**Comment Response Matrix  
for  
Nuclear Regulatory Commission (NRC)  
Requests for Additional Information (RAIs) on the  
Saltstone Disposal Facility Performance Assessment  
(SRR-CWDA-2009-00017, Revision 0, dated October 29, 2009)**

July 23, 2010

Prepared by: Savannah River Remediation (SRR)  
Closure & Waste Disposal Authority  
Aiken, SC 29808

**Figure PA-2.1: Peak Mean Dose to a MOP, Any Sector- Case E  
(modified from Figure 5.6-38 in SDF PA)**

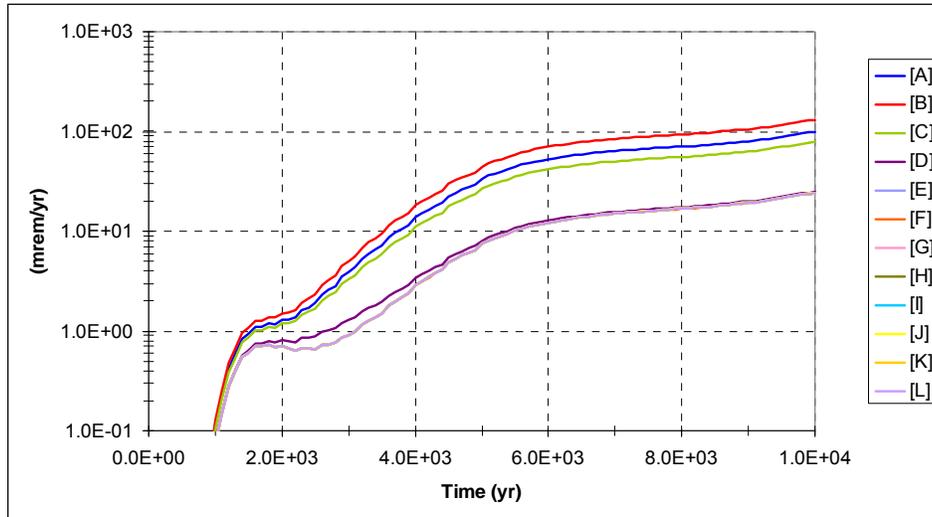
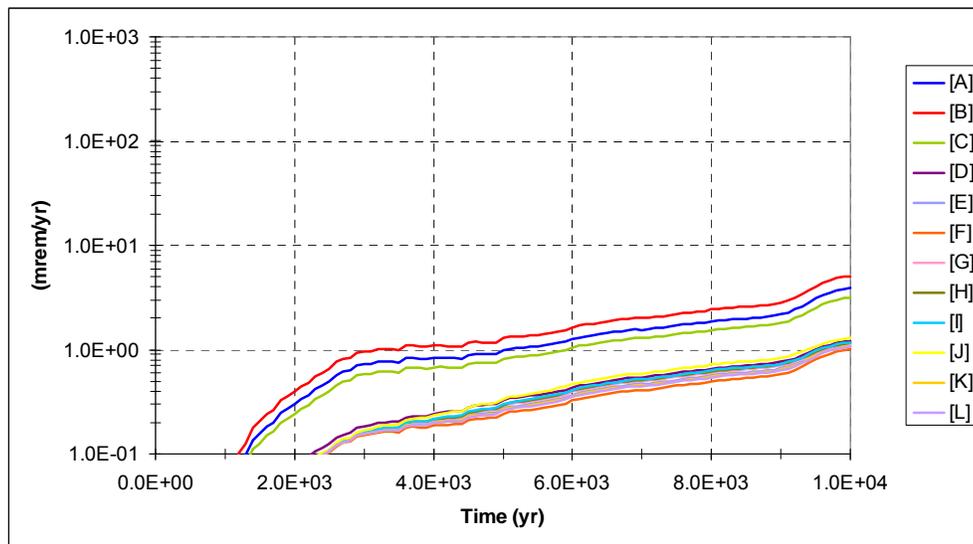
<p><b><u>PA-2</u></b></p>	<p>Probabilistic sensitivity analyses were not provided for cases representing bulk saltstone degradation.</p> <p><b><u>Basis</u></b></p> <p>Probabilistic sensitivity analyses were performed only for Cases A and C. Although Case C represents a fast flow pathway through saltstone, neither Case A nor Case C represents degradation of the bulk saltstone matrix. Case E, which represents saltstone degradation, was not included in the sensitivity analysis. Dose sensitivities in a case with degraded saltstone are expected to be different from the sensitivities in a case without degraded saltstone. For example, because chemical transitions would be achieved earlier in a case in which bulk saltstone has a greater hydraulic conductivity, parameters affecting the transport of radionuclides sensitive to pH transitions in saltstone may have a greater effect on dose. Similarly, parameters related to slower-moving radionuclides (e.g., plutonium) may have a more significant effect on dose in a case in which more water moves through the bulk saltstone. The sensitivity of these parameters is important to identifying issues that should be tracked during monitoring.</p> <p><b><u>Path Forward</u></b></p> <p>Provide a probabilistic sensitivity analysis for a case that reflects saltstone degradation, or explain why the sensitivity analyses performed in the PA are expected to reflect the sensitivities of dose in a case that reflects saltstone degradation. If a new sensitivity analysis is performed, it should be consistent with any modifications made in response to the comments in this document.</p>

<p><b><u>RESPONSE PA-2:</u></b></p> <p>This response provides results for the probabilistic uncertainty and sensitivity analysis for the severely degraded saltstone Case E over 10,000 years. Degraded saltstone is assumed to take the form of cracked grout and has been modeled by increasing its hydraulic conductivity to a value of 1.7E-3 cm/sec.</p> <p>As emphasized in SDF PA Section 5.6.4, the results of the uncertainty and sensitivity model are not intended to predict future potential dose for comparison to performance objectives (the SDF PORFLOW model has been used for assessment of peak doses versus performance objectives). Rather, the goal of this SDF modeling is to characterize the context of uncertainty and sensitivity surrounding the PA calculations involving doses to MOP exposed via groundwater. Case E is an extreme case based on the very high hydraulic conductivity value used, which is approximately two orders of magnitude higher than backfill soil. The relative influence of Case E on the composite "AllCases" result is evident by comparing Figure PA-2.1 and Figure PA-2.2 below.</p>

Figure 1: Moisture characteristic curves adapted from the PA and WSRC-STI-2006-00198

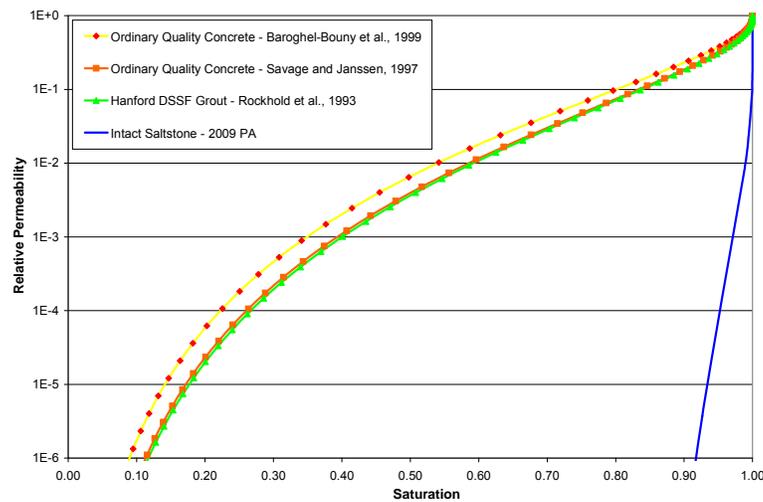
The PA implements curves substantially different from those found in literature. For example, the curves in the PA are significantly different from the curves discussed in "*Hydraulic Property Data Package for the E-Area and Z-Area Soils, Cementitious Materials, and Waste Zones*" (WSRC-STI-2006-00198) (Figure 1). The moisture

Provide additional justification for the moisture characteristic curve for intact saltstone implemented in the PA model by addressing the experimental sources of uncertainty described in the basis. Alternately, provide updated results of Cases A, B, C, D, the synergistic case, and the sensitivity case in Section 5.6.6.7 that use a characteristic curve for intact saltstone that is more consistent with results in the literature. Any updated analysis should be consistent with the response to SP-4.

**Figure 2: Characteristic curves for the intact and fractured saltstone and concrete as adapted from the 2009 PA and SRNL-STI-2009-00115**

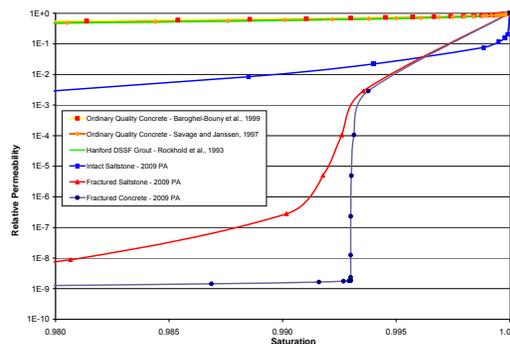
The characteristic curves developed by INL (referred to in SP-3) were also used as the basis for the fractured saltstone and concrete characteristic curves (see Figure 2 below) that were developed in “*Numerical Flow and Transport Simulations Supporting the Saltstone Disposal Facility Performance Assessment*” (SRNL-STI-2009-00115). The authors discuss the use of an analytical approach developed by Or and Tuller (2000) to adapt INL moisture characteristic curves for cracked cementitious materials because experimental characteristic data for cracked vault concrete and saltstone grout are not available (SRNL-STI-2009-00115). However, use of moisture characteristic curves combined with coarse spatial and temporal averaging can result in an inadequate representation of non-equilibrium flow.

Provide additional support for the modeled flow through fractures. Model support could include field observations and laboratory experiments that verify consistency between numerical results and physical measurements.

**Figure SP-6.1: Calculated Peclet Number for SDF PA Case A**

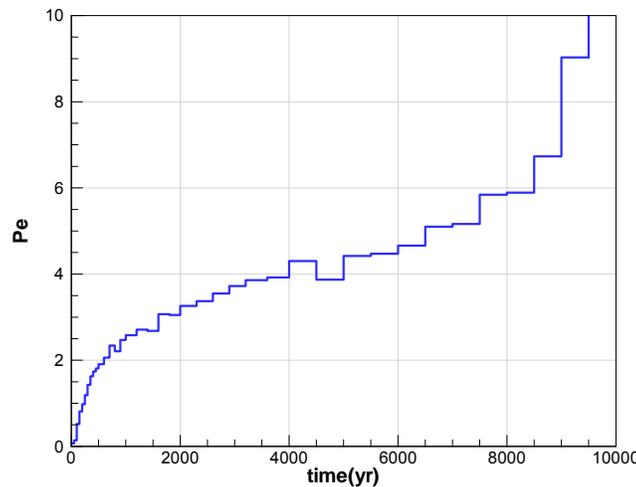
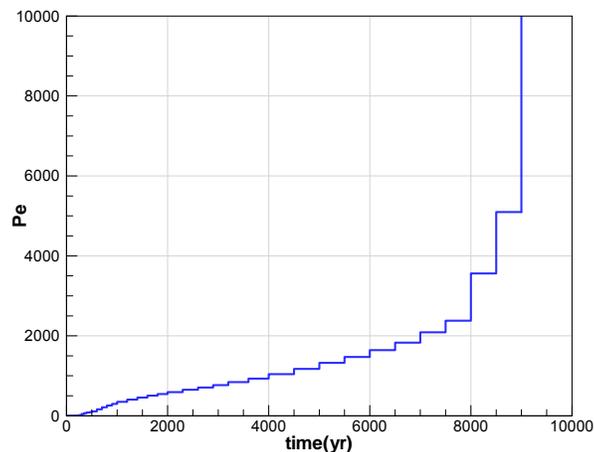
<p><b><u>SP-6</u></b></p>	<p>Comment: Additional basis is required for the values of the effective diffusivity of intact and degraded saltstone used in the base case and sensitivity cases.</p> <p><b><u>Basis</u></b></p> <p>As discussed in comment SP-1, the effects of degradation of bulk saltstone (as compared to fractures in otherwise intact saltstone) are addressed in sensitivity Case E, in the synergistic case discussed in Section 5.6.6.5, and in an increased saltstone hydraulic conductivity case discussed in Section 5.6.6.7. In each of these cases, the hydraulic conductivity of saltstone is adjusted, but the effective diffusivity is kept constant at the base-case value. Because both the effective diffusion coefficient and hydraulic conductivity are intimately related to pore structure in cementitious materials, it is reasonable to expect that both coefficients would increase as saltstone degrades. The basis for adjusting the hydraulic conductivity in the sensitivity cases but maintaining the effective diffusivity at the base-case value does not appear to be addressed in the PA.</p> <p>In addition, clarification is needed of the basis for the effective diffusivity of intact saltstone. The supporting document “Numerical Flow and Transport Simulations Supporting the Saltstone Disposal Facility Performance Assessment” (SRNL-STI-2009-00115) indicates that the effective diffusivity is based on a comparison to other cementitious materials with similar hydraulic conductivities, but the specific materials used for comparison and the process by which an effective diffusivity value was selected are not provided. Table 4.4-16 of the PA indicates that the effective diffusion coefficient is based on the effective diffusion coefficient of high quality concrete in the supporting document “Hydraulic and Physical Properties of Saltstone Grouts and Vault Concretes” (WSRC-STI-2006-00198). However, the actual value of the effective diffusion coefficient for high quality concretes provided in Tables 6-44 and 6-47 of WSRC-STI-2006-00198 is 5 E-8 cm<sup>2</sup>/s, which does not match the value of 1.0 E-7 cm<sup>2</sup>/s used in the PA for saltstone. Furthermore, it is not clear why an effective diffusivity value appropriate for high quality concrete, which has a porosity of 0.11 (PA Table 4.2-16) would be appropriate for saltstone, which has a porosity of 0.58 (PA Table 4.2-16). While the choice of an effective diffusion coefficient of 1.0 E-7 cm<sup>2</sup>/s is more pessimistic than the value provided for high quality concrete in the supporting document, the basis for the effective diffusivity value chosen should be clarified.</p> <p><b><u>Path Forward</u></b></p> <p>Provide a basis for using the effective diffusivity of intact saltstone in the two sensitivity cases that address degraded saltstone listed in the basis or update the sensitivity cases that address degraded saltstone with a value of effective diffusivity that reflects the physical degradation of the wasteform. Clarify the basis for the value of the effective diffusivity of intact saltstone.</p>

<p><b><u>RESPONSE SP-6:</u></b></p> <p>While the diffusion coefficient would be expected to increase as the saltstone degrades, the transport is advection dominated except during the first few hundred years after closure as indicated by the Peclet number for Case A for Vault 4 as presented in Figure SP-6.1. As indicated in Figure 5.5-1 in the SDF PA, the peak dose in 10,000 years is in Sector B at year</p>

10,000 and is dominated by releases from Vault 4. At year 10,000 the Peclet number is greater than 10 indicating the dominance of advective versus diffusive transport. Therefore, any change in the diffusion coefficient will not have a noticeable impact on the calculated peak dose results.

Similarly, for Case E (the configuration case with significantly degraded saltstone properties) Figure SP-6.2 presents the Peclet number for Vault 4 within 10,000 years. As indicated in Figure 5.6-72 in the SDF PA, the peak dose in 10,000 years is in Sector B at approximately year 9,400 and the Peclet number is greater than 10,000 indicating the dominance of advective versus diffusive transport. As in Case A, any change in the diffusion coefficient will not have a noticeable impact on the calculated peak dose results.
